## V2500-A1/A5 SERIES NACELLE SERVICE BULLETIN

This document transmits Revision 1 to Service Bulletin NV2500-78-0199

# V2500-NAC-78-0199

NACELLE – THRUST REVERSER – AFT SUPPORT RING REPLACEMENT – BLANK CASCADE REPLACEMENT  
– ACTUATOR COVER REPLACEMENT

Aft Cascade Ring Replacement  
Figure 1

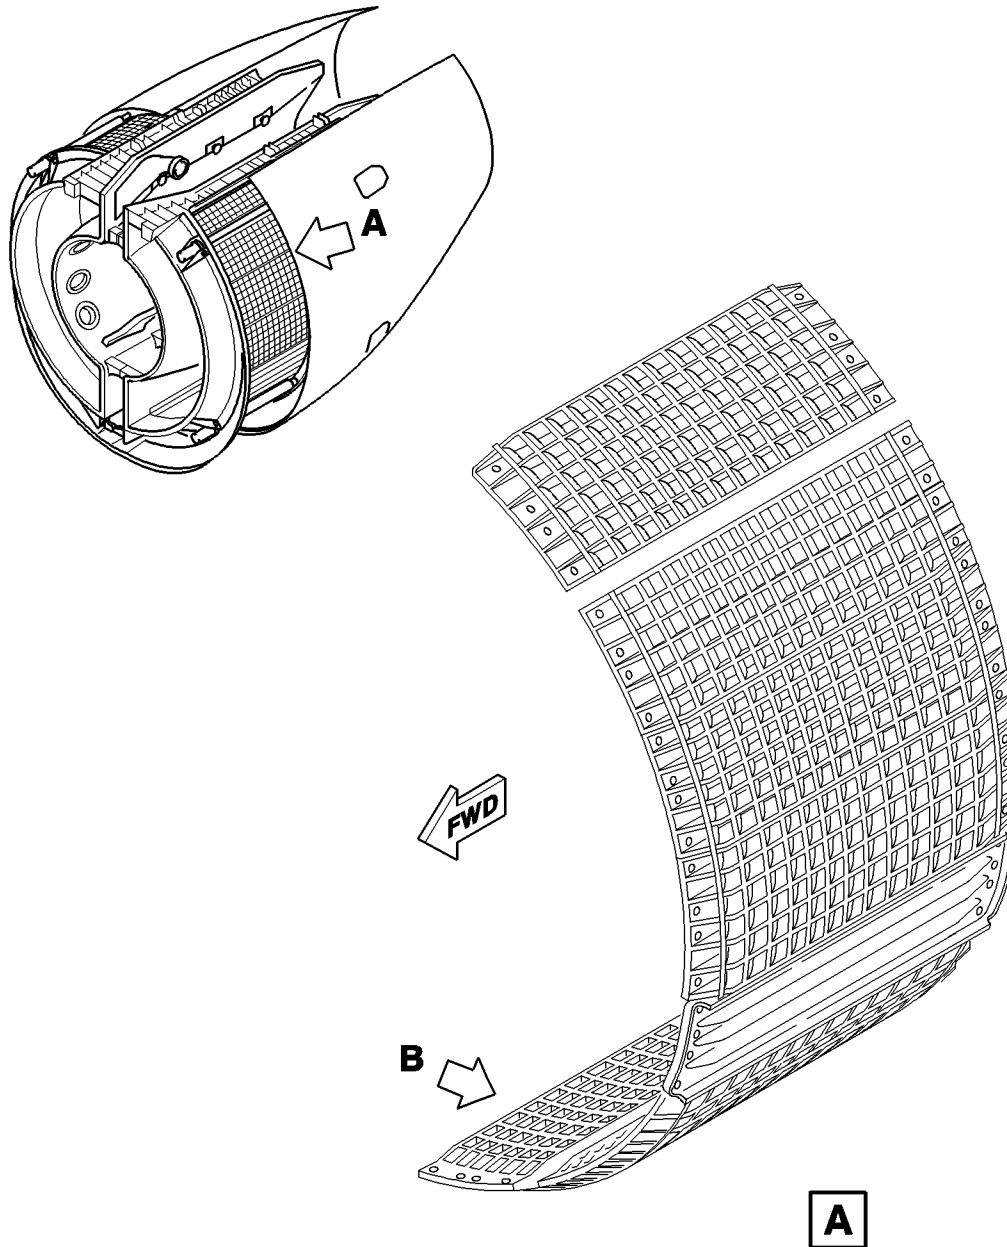
R This Service Bulletin provides instructions to install a new aft support ring  
R (Refer to Figure 1, Sheet 1), new blank cascades made of composite material  
R (Refer to Figure 3) and new actuator covers (Refer to Figure 4).

(10) Install the new ring with the retained hardware. Torque the MS21042-6 nut to 160 - 190 in-lb (18,0 - 21,5 Nm). Torque the MS21042-5 nut to 100 - 140 in-lb (11,3 - 15,8 Nm).

Aft Cascade Ring Replacement – Install the Deflector Box, Eng No.1, LH Side  
Figure 2 (Sheet 1)

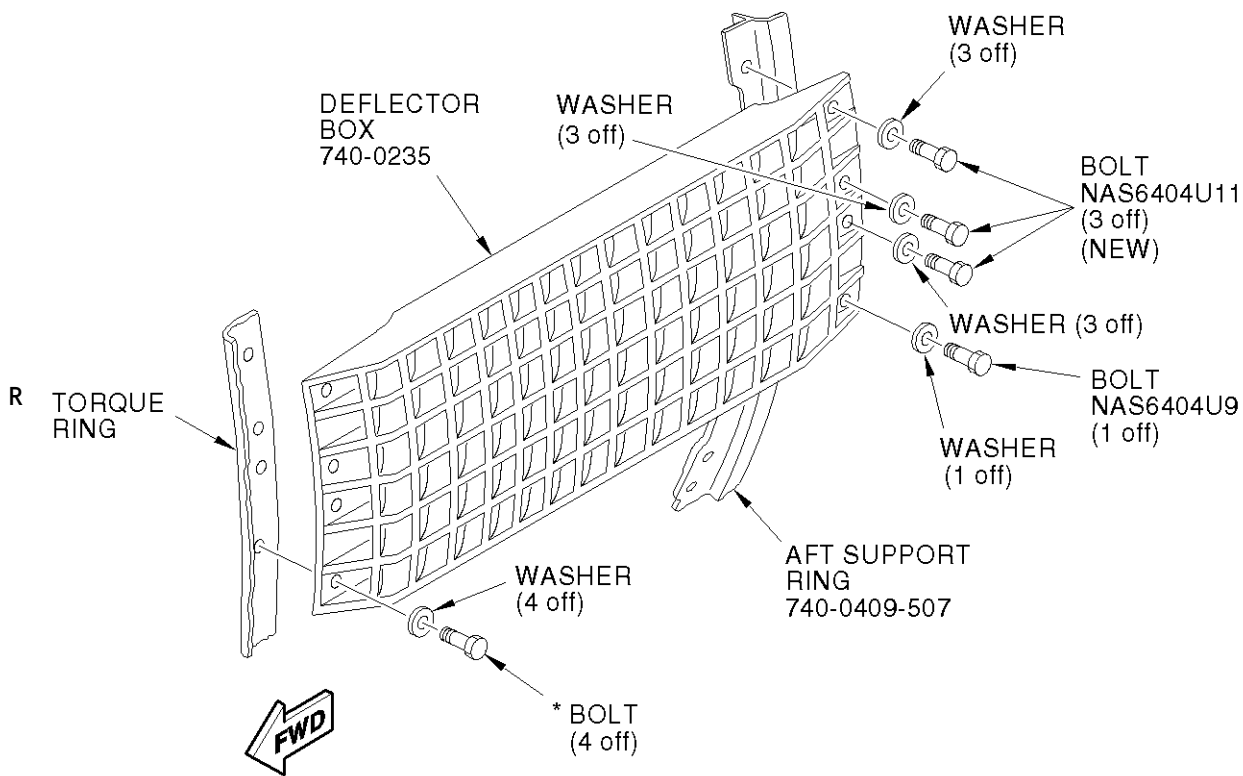
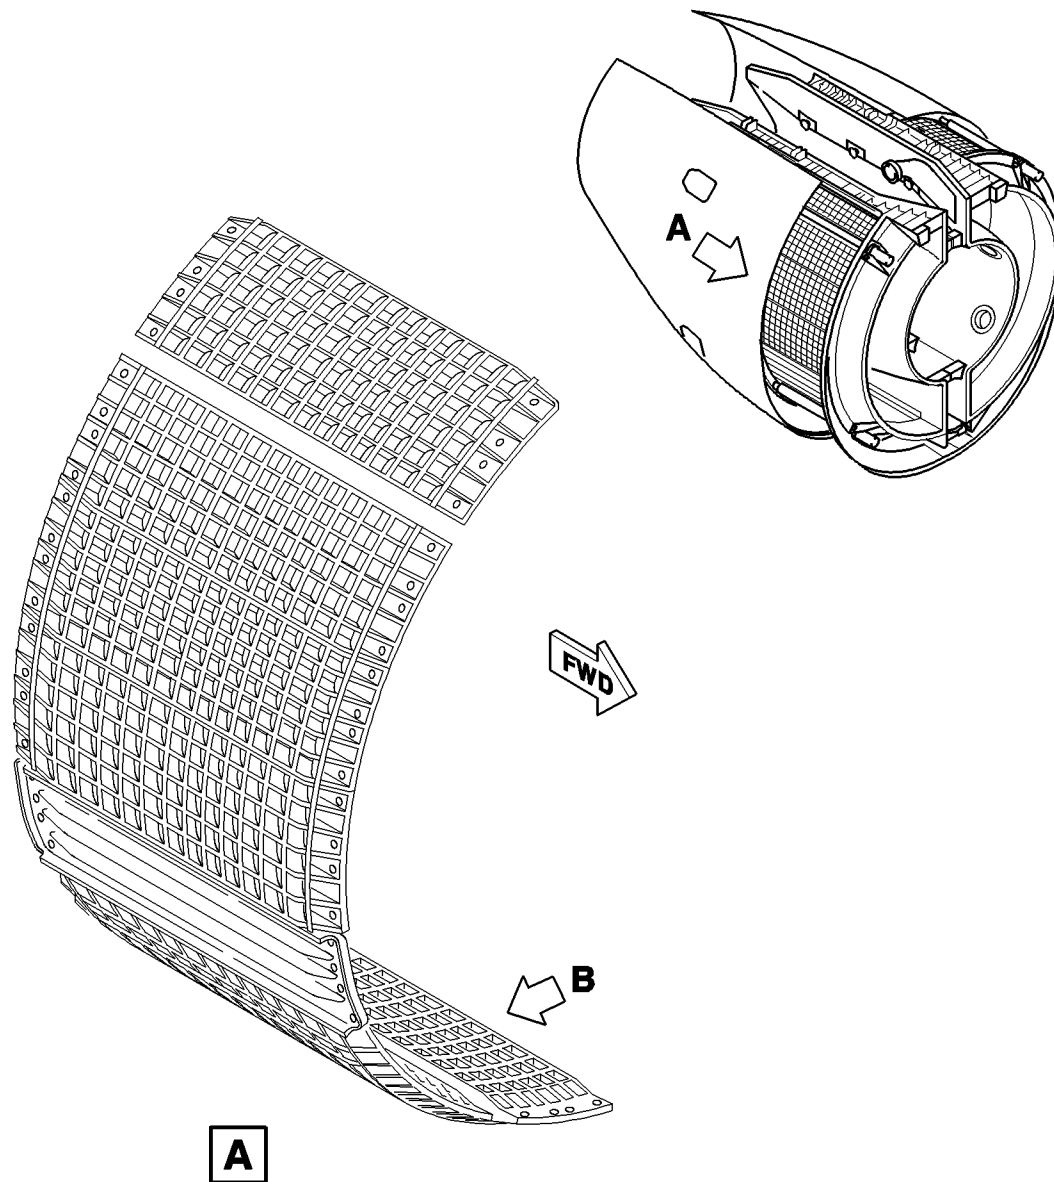
**NOTE:** One deflector box per nacelle requires three new, longer bolts to support the new configuration. See Figure 2 for detail information.

\* If bolt is too long, you can install an extra washer under the head of the bolt.

Aft Cascade Ring Replacement – Install the Deflector Box, Eng No.2, RH Side  
Figure 2 (Sheet 3)

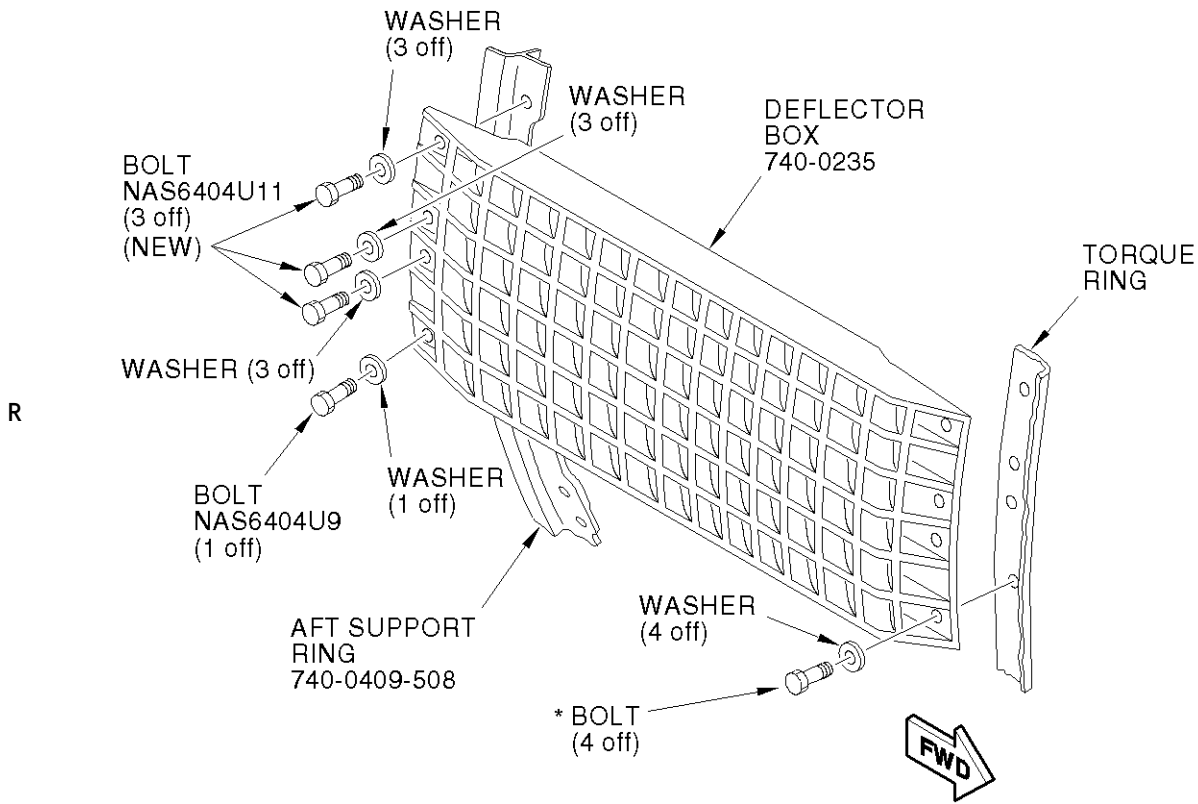
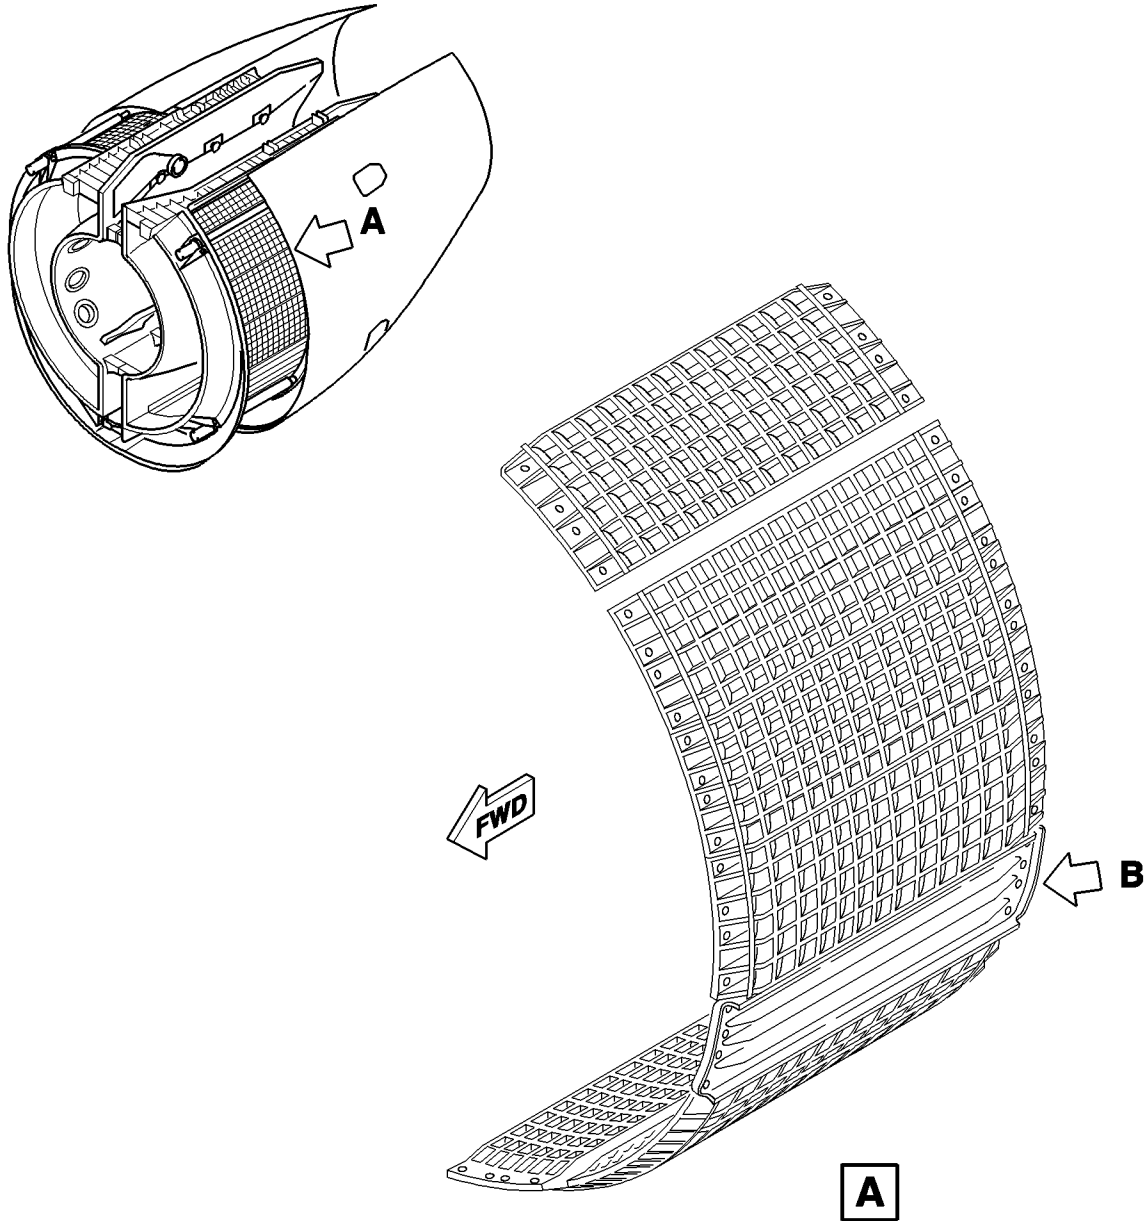
\* If bolt is too long, you can install an extra washer under the head of the bolt.
